CHATHAM COUNTY PURCHASING DEPARTMENT

ADDENDUM NO. 2 TO BID NO. 13-0111-4

FOR: WALTHOUR BETZ CREEK BRIDGE REPLACEMENT

WATER MAIN HANGER DETAIL

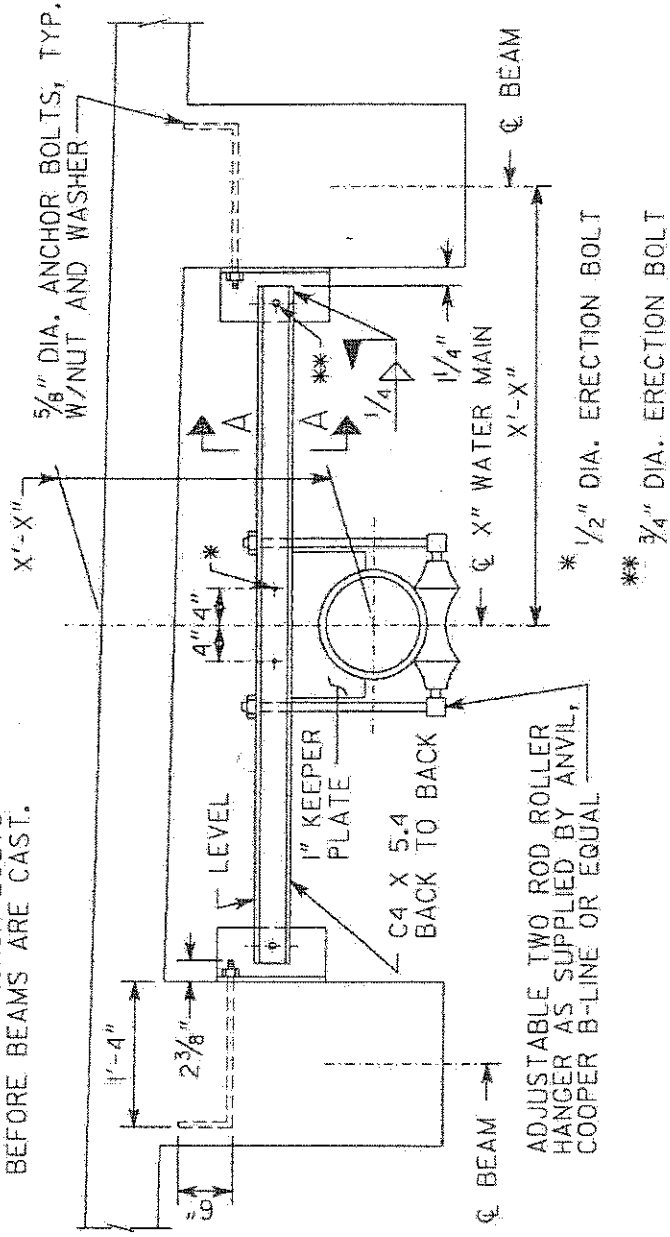
General Note 12 is revised to include the following: The contractor shall install the galvanized anchor bolts as shown in the attached water main hanger detail for future use. The hangers and hanger assemblies, will be provided and installed by others at a later date. The beams will remain the same type and size, however, minor revisions to accommodate the water line hangers will be provided prior to construction.

NOTE: SPACE WATER MAIN HANGERS AT 10'-0" ON CENTERS. SPACE HANGERS TO CLEAR ALL EDGE BEAMS AND INTERMEDIATE BENTS.

NOTE: SET ANCHOR BOLTS BEFORE BEAMS ARE CAST.
